RE: BC Ph 15S Perimeter Buffer - Thomas Follow-up

Thanks for your time the past several days. Attached are drawings regarding the 100' perimeter buffer waiver request that we have discussed.

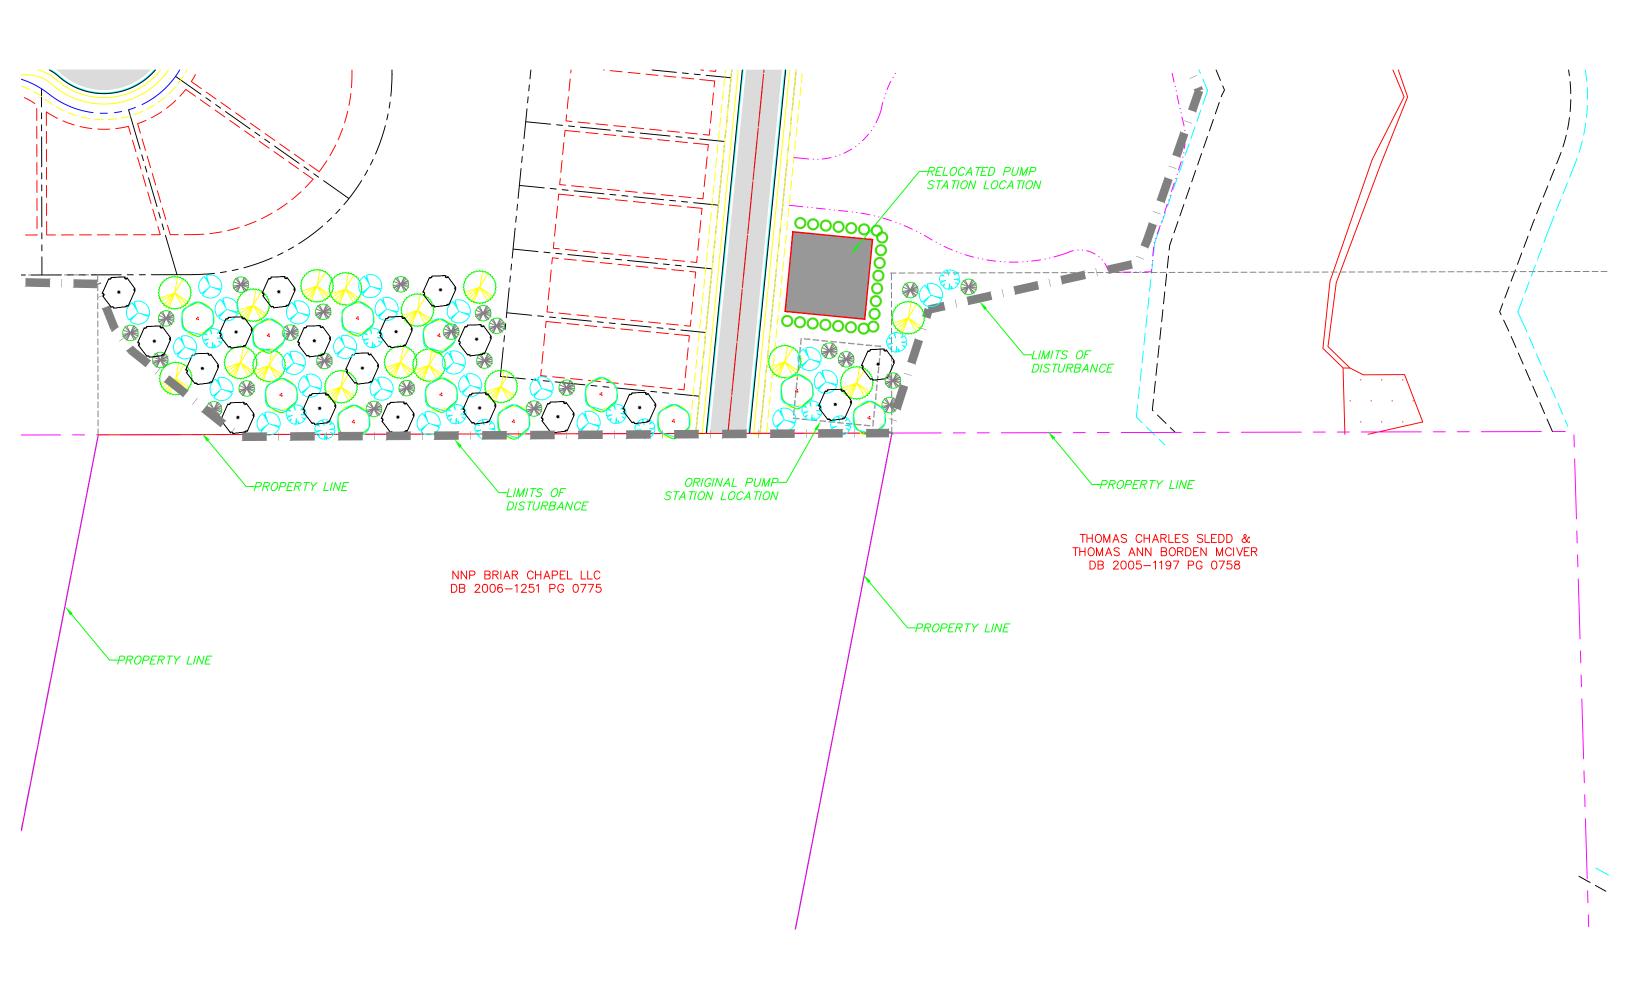
• In the pdf, "2017.04.26 PS shift-site (2)", the proposed shift of the pump station from the edge of the property line to approximately 75' north of your property corner with Briar Chapel is shown.

• In the pdf, "2017.05.02 PS shift", the proposed re-vegetation plan for the areas between the property line and the pump station is shown. Other than an evergreen shrub hedge around the pump station perimeter, the revegetation plan follows the previously approved Briar Chapel buffer revegetation detail (Figure 15). [Please note that this detail is attached as pdf, "Revegetation Buffer Detail". Also, as an FYI, this revegetation plan is proposed to be utilized in areas are the other side of the future road as well as areas that are not future lots.]

So, this note is to confirm that we are in agreement with their wishes to come inside the 100' buffer as described below and in the original pdf attachments (listed below).
